SURFACE TRANSPORTATION BOARD
Washington, DC 20423

Office of Environmental Analysis

Re: Docket No. FD 35852, Canaveral Port Authority — Construction and
Operation Exemption — Rail Line Extension to Port Canaveral, Florida;
Information Request #2

Proposed CCAFS & SR-528 Rail Alignments

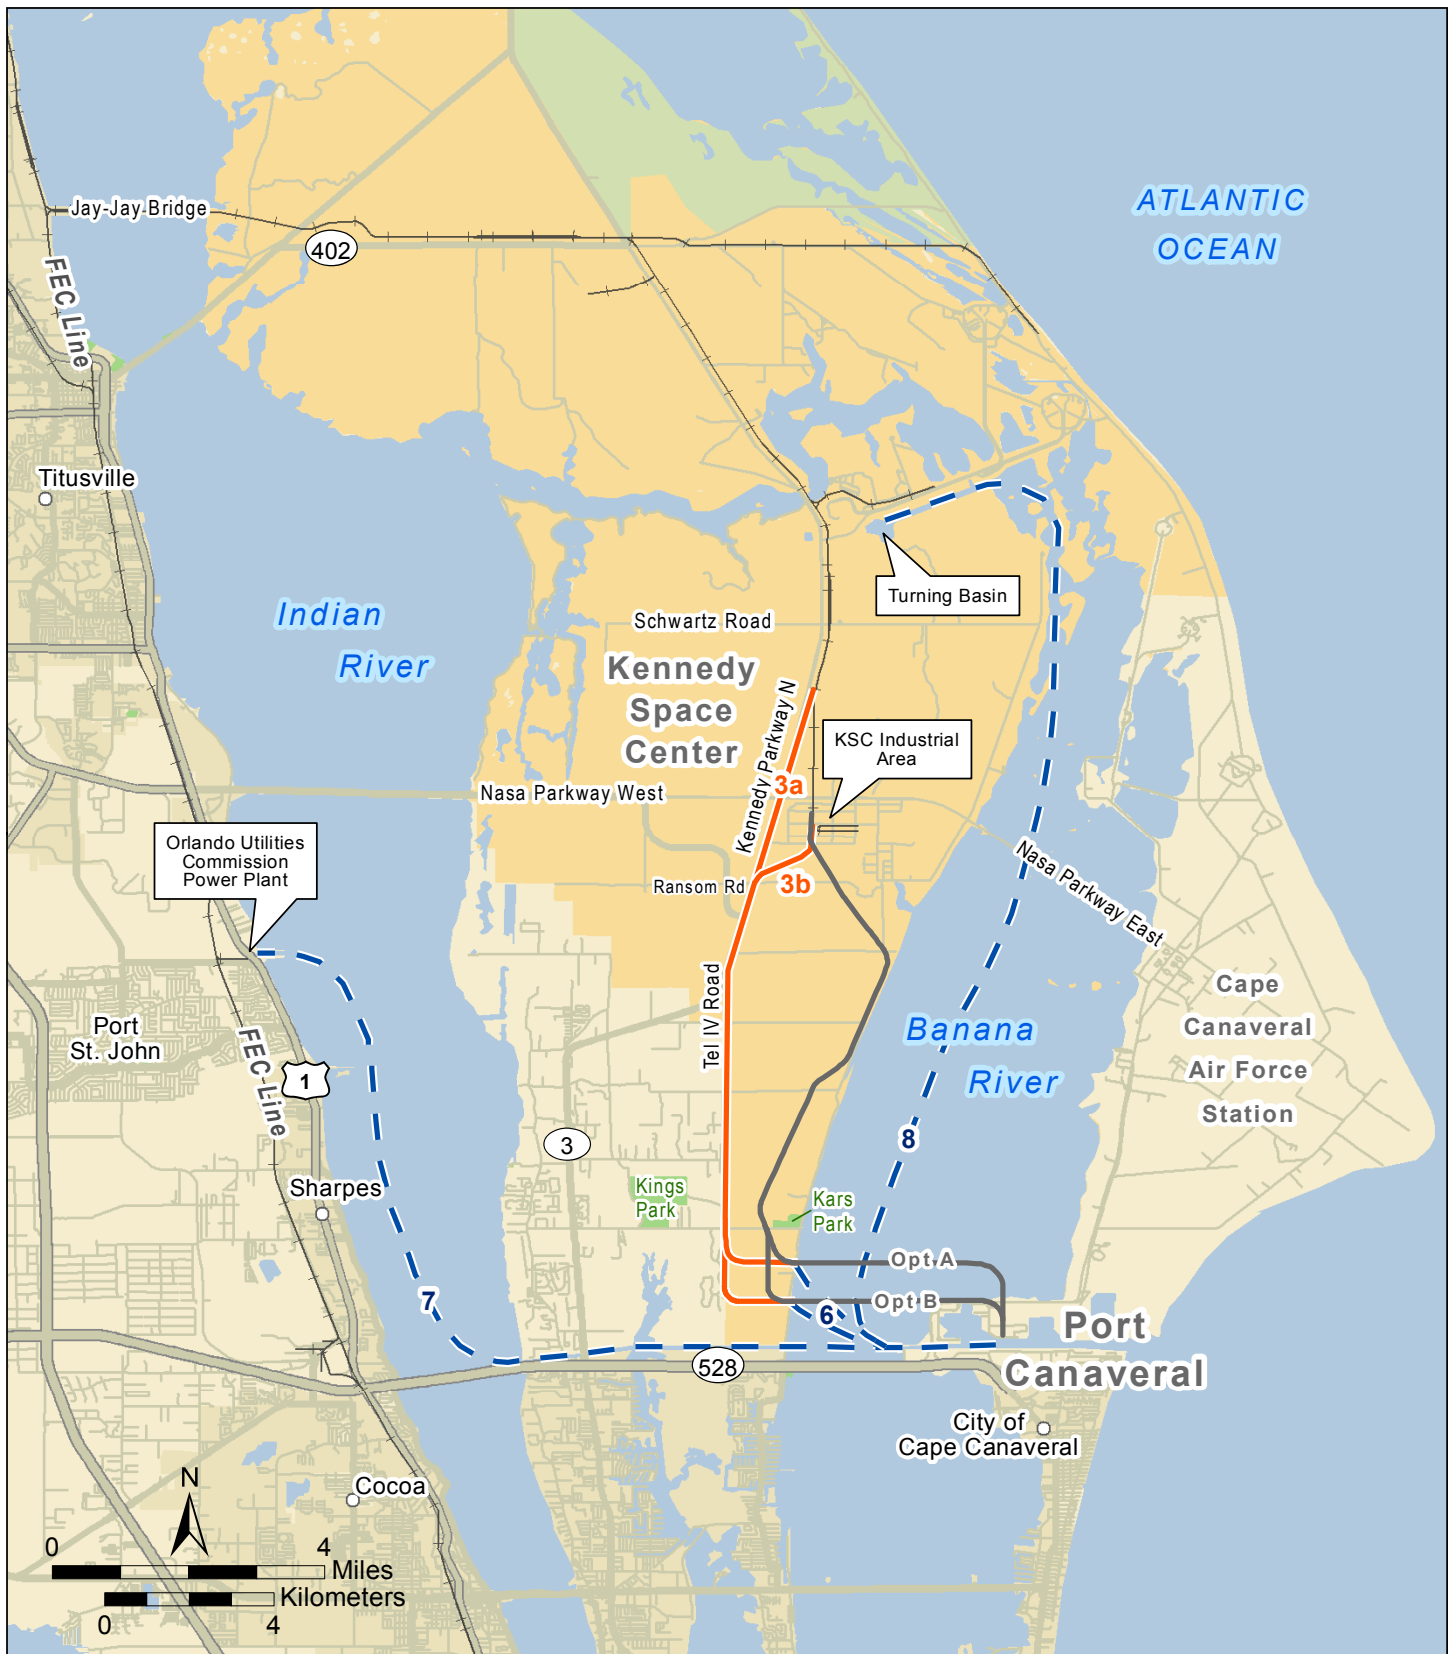
1. A number of scoping commenters proposed alignments that would cross the U.S. Air Force Cape Canaveral Air Force Station (CCAFS). They include the following proposed alignments (see enclosed figure, *Proposed CCAFS & SR-528 Rail Alignments*):
 - a. An alignment that would travel north through the CCAFS to the Launch Complex (LC)-39 Pad Area and connect with the National Aeronautics and Space Administration (NASA) Kennedy Space Center (KSC) rail line in that area.

- b. An alignment that would travel north through CCAFS and would depart CCAFS on NASA Parkway East, which it would follow until joining the existing rail in KSC.
- c. An alignment that would travel north through the CCAFS, specifically along the western shoreline of CCAFS, until leaving the CCAFS along the southern shoulder of NASA Parkway East.
- d. An alignment that would travel north through CCAFS via alignments 1b or 1c, and at the industrial area would turn west and leave the KSC along NASA Parkway West to the existing Florida East Coast Railway (FEC) main line.

Please provide any available written documentation concerning CCAFS's position on having the proposed rail line extension located on CCAFS grounds.

- 2. A number of commenters proposed alignments that would generally follow State Road (SR) 528. These include the following proposed alignments (see enclosed figure, *Proposed CCAFS & SR-528 Rail Alignments*):

- a. An alignment from the Port, following SR-528 until reaching the existing FEC main line.
 - b. An alignment that would run due west from the Port, parallel to the barge canal to the Indian River, then parallel to SR-528 at the Indian River crossing until reaching the FEC.

Proposed Eastern KSC Rail Alignments

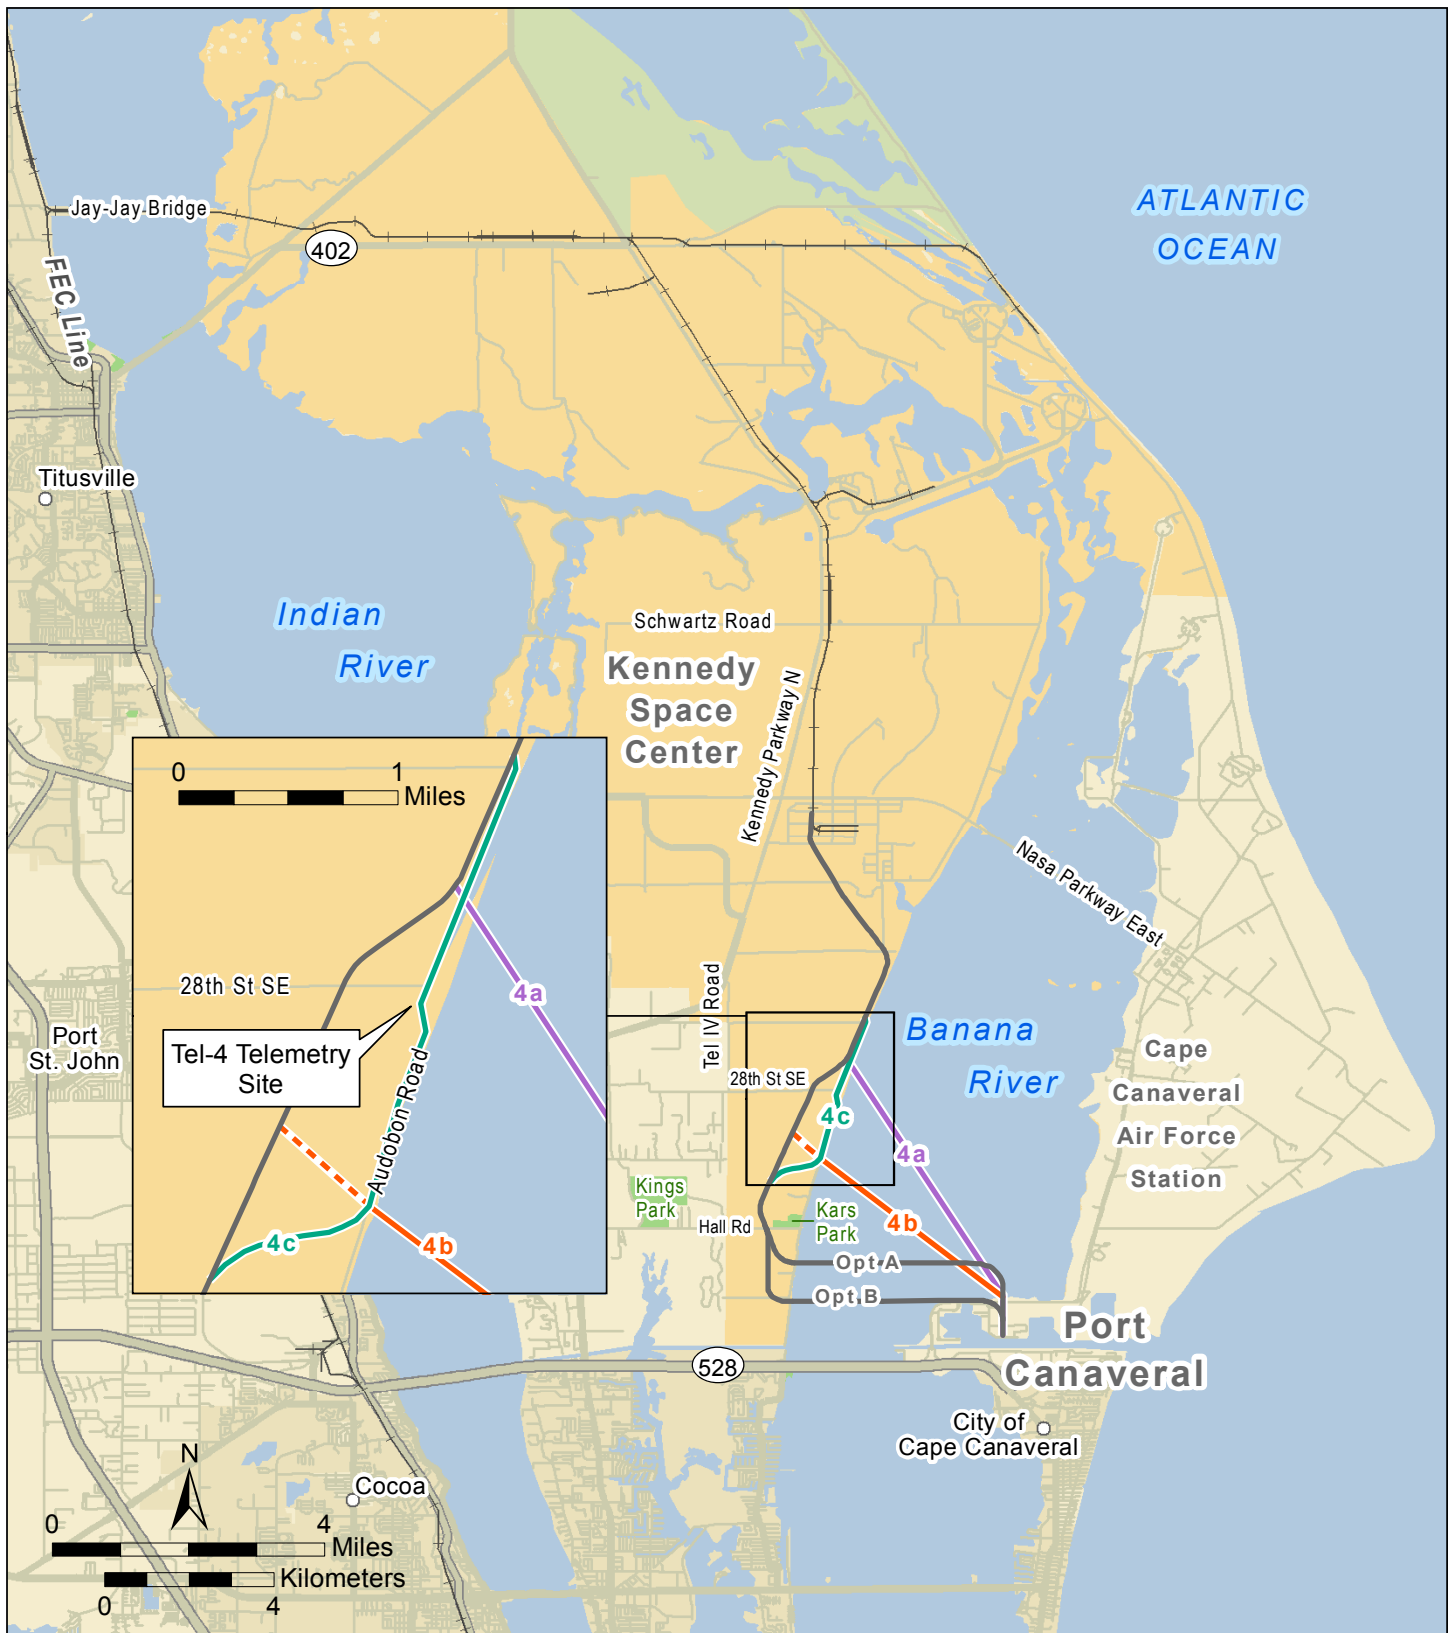
- 4. Several comments were submitted regarding the feasibility of alignments located along the eastern side of the KSC property. This includes the following proposed alignments (see enclosed figure, *Proposed Eastern KSC Rail Alignments*):

- a. An alignment that leaves the Port near the same location as the proposed “Option A” but travels across the Banana River bearing to the northwest until reaching the KSC property just to the north of 28th Street SE and following the alignment for “Option A” from that point.

- b. An alignment that would cross the Banana River on a northwest bearing until reaching KSC property at a point between Kars Park and the Tel-4 Telemetry Site.

- c. An alignment that would follow either Option A or Option B across the Banana River and around Kars Park to a point approximately 0.7 mile north of Hall Road, where the alignment would travel northeast to Audobon Road, which it would follow until joining the Option A/B alignment.
